PLANNING BOARD MEETING

Trim Way Def. Subdivision- Response to Peer Review Comments

358 & 360 North Street Randolph, MA 02368

Trim Way

C-201 LOTTING PLAN

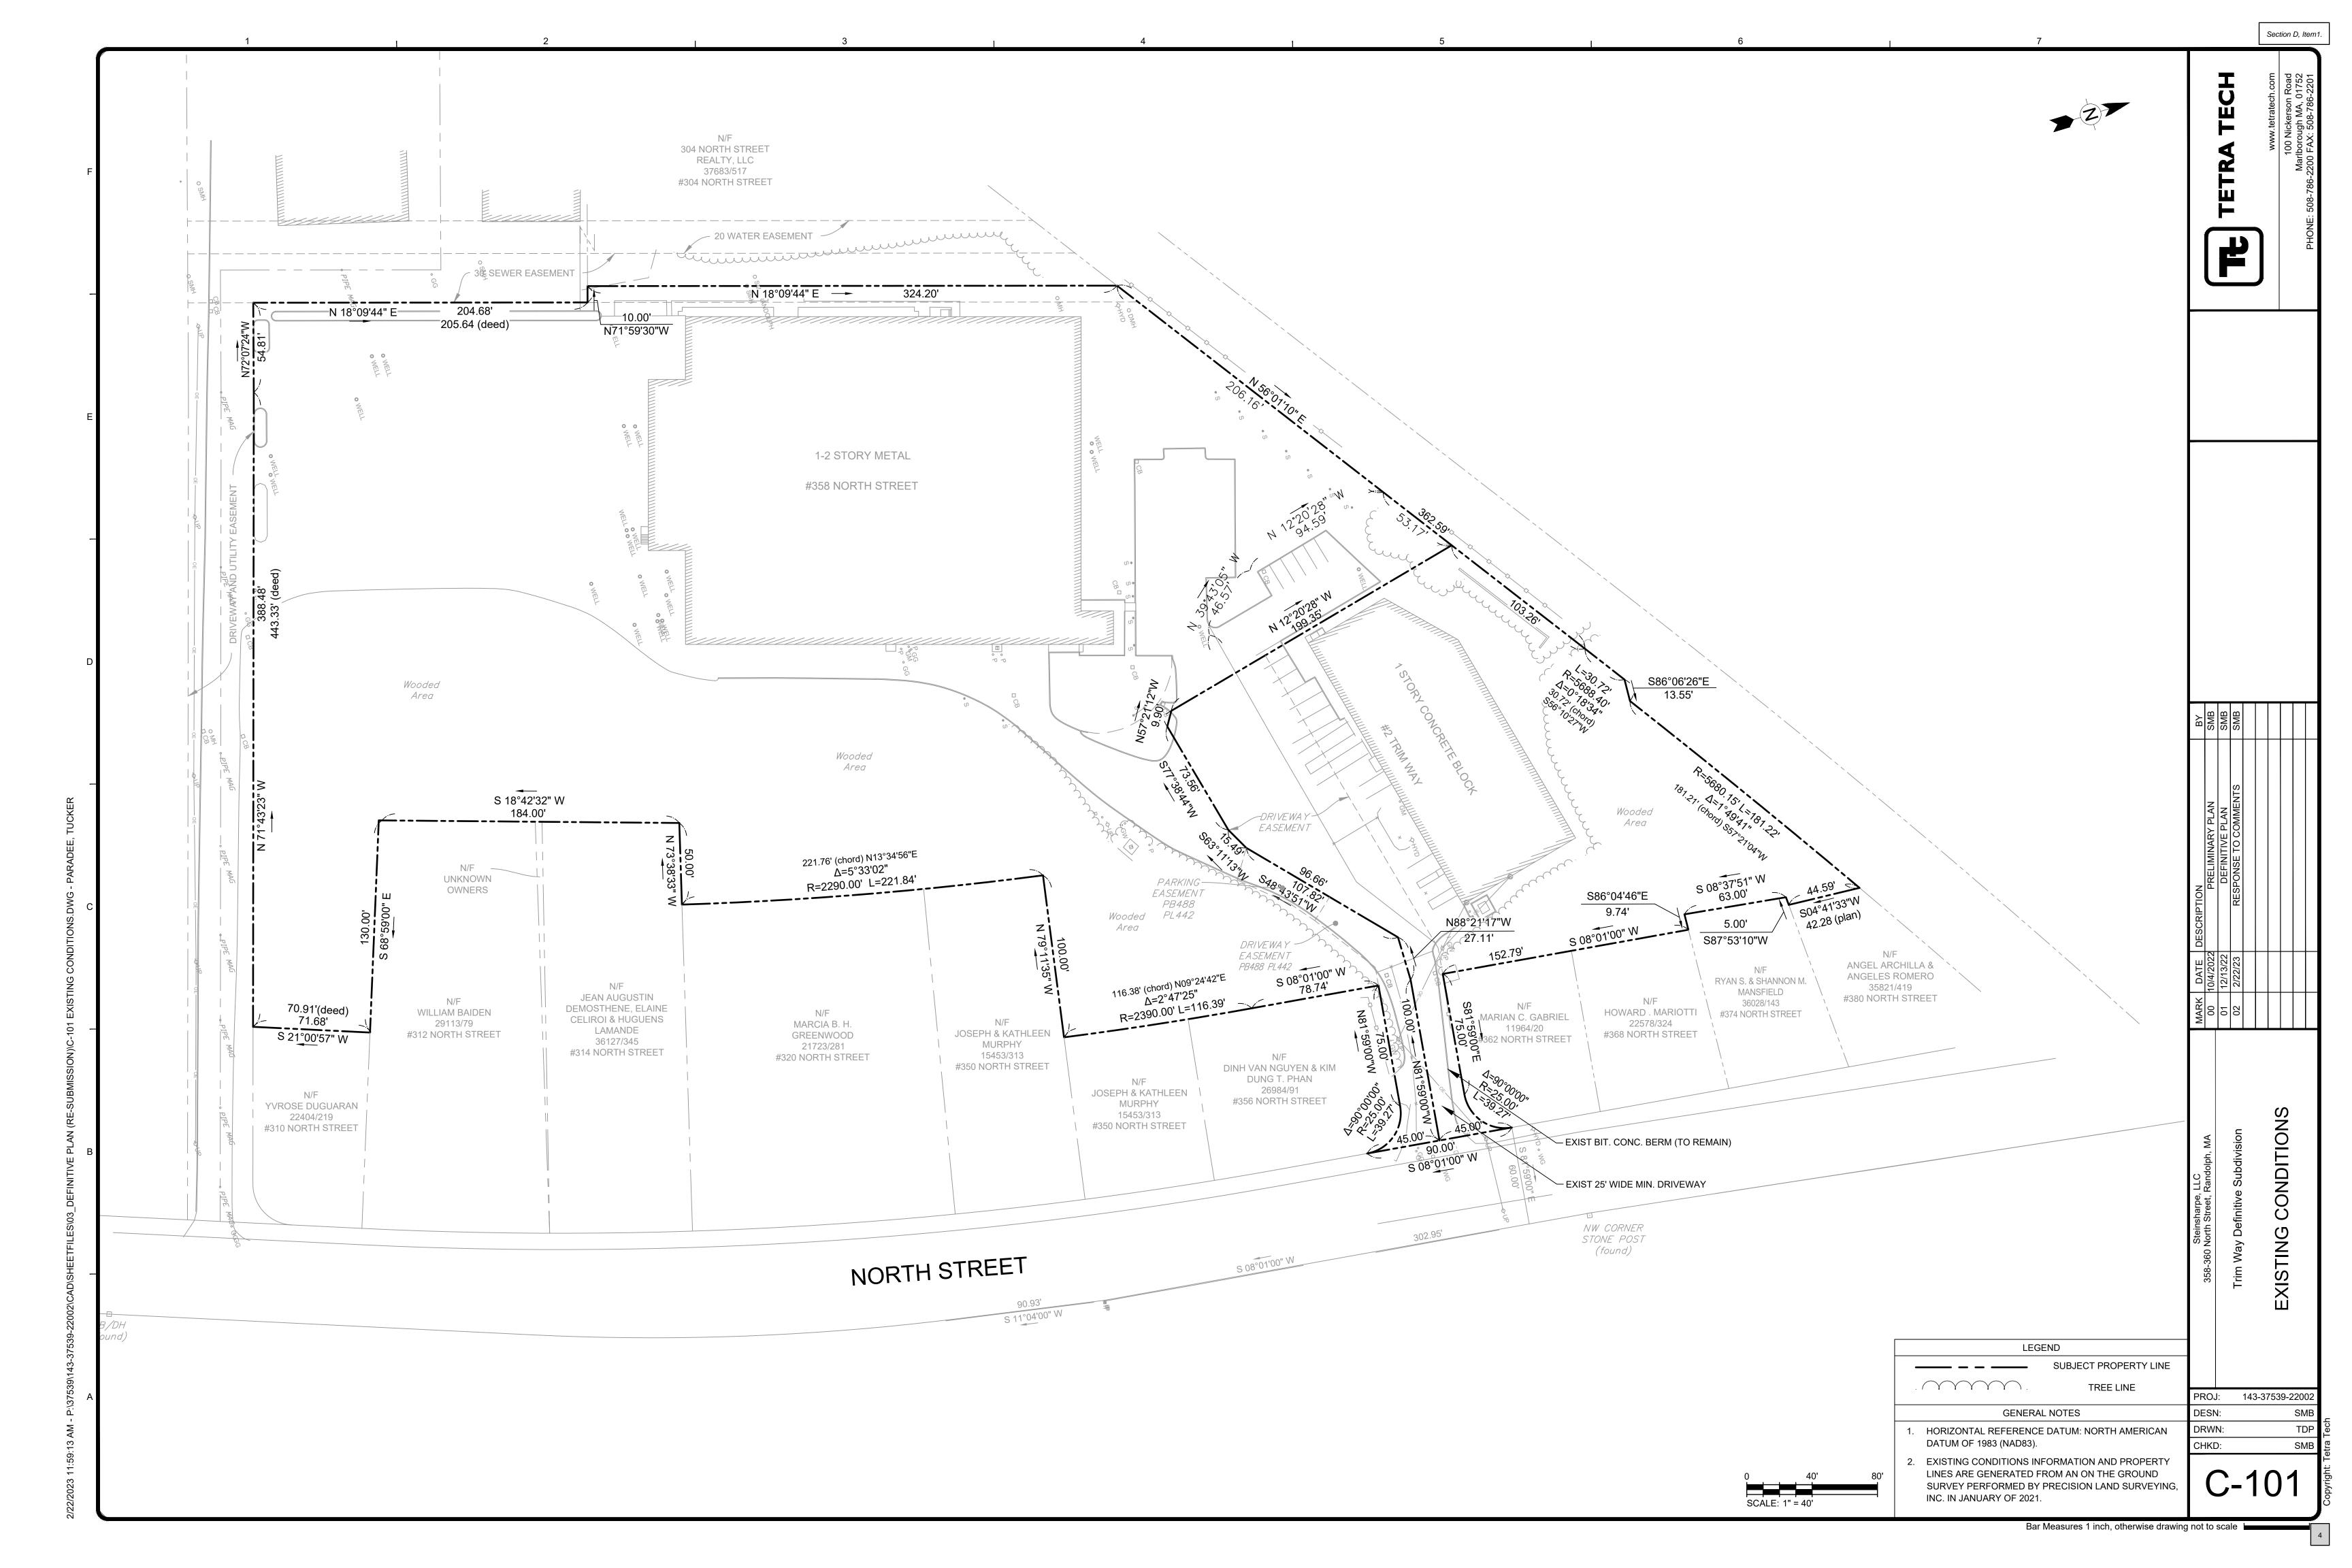
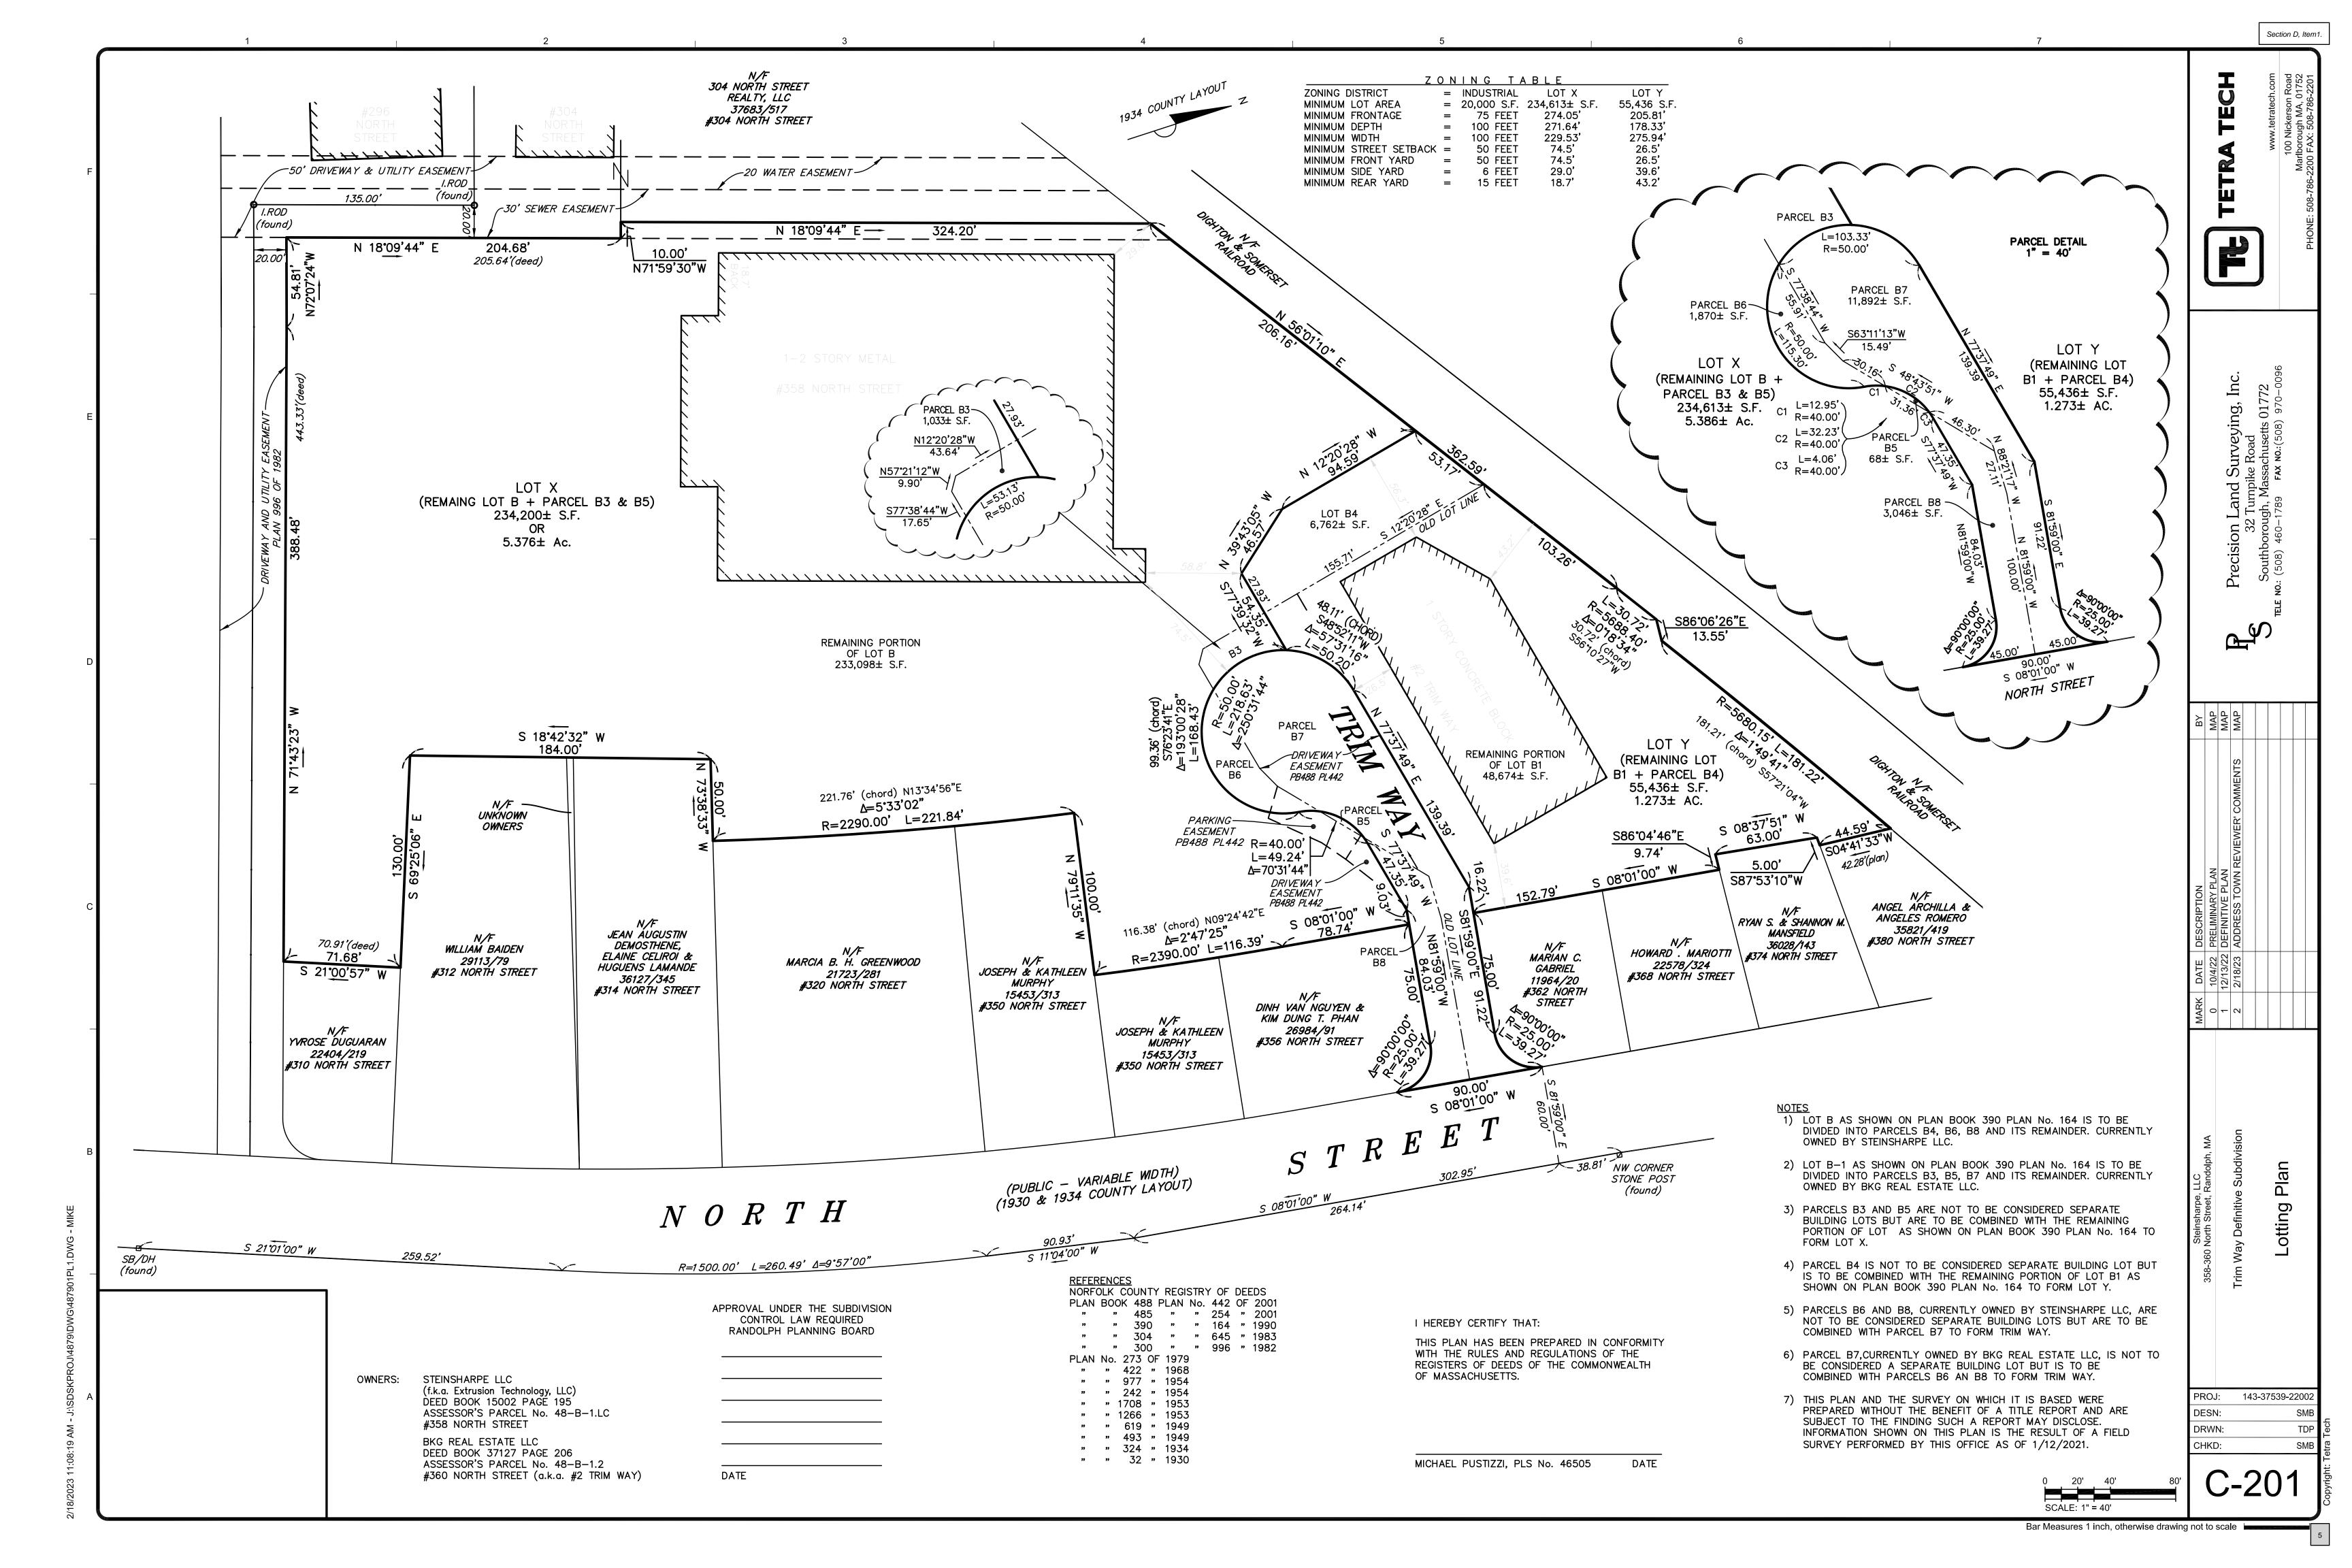
- 1. Several of the distances shown on the Lotting Plan differ from the record deed or plan for the parcel. See green highlighted distances on the attached plan.

- 2. A portion of the existing driveway easement is shown on the south side of Trim Way, but it is not labeled as such. There is also a parking easement adjacent to the driveway easement that is not shown at all. If these easements have not been extinguished, they should be shown on this plan.

- o TT/PLS 2/22/23 Response: They have been added and labeled on the updated Lotting Plan.
- 3. There appears to be two (2) property lines between #312 and #314 North Street. It is unclear if this is indicating a gap or overlap in the lots, but there is no indication in the record documents that this should be the case.

- 4. The Owner and Title reference are not given for #310 North Street.
 - o TT/PLS 2/22/23 Response: They have been added and labeled on the updated Lotting Plan.

- 5. The 50-foot easement line is not fully plotted.
 - o TT/PLS 2/22/23 Response: Item has been added and labeled on the updated Lotting Plan.
- 6. The lot for #304 North Street is comprised of two (2) lots under common ownership. The way the Lotting Plan shows the internal lot line makes it appear as though they are separate lots. A fee hook or some notation that the line is an internal lot line would clarify this.

- TT/PLS 2/22/23 Response: We have addressed the areas of differences. There was a difference in boundary line location as showcased on an AUL plan prepared by Hancock, supplied by the owner and attached to this letter. This plan and the monuments shown were used to help set the southern boundary. Other calculation differences have been called out as deed/plan.

- TT/PLS 2/22/23 Response: There appears to be a difference in the two abutters' deeds where neither deed is claiming this sliver. We have labeled this area as owner unknown.

- o TT/PLS 2/22/23 Response: They have been added and labeled on the plan.
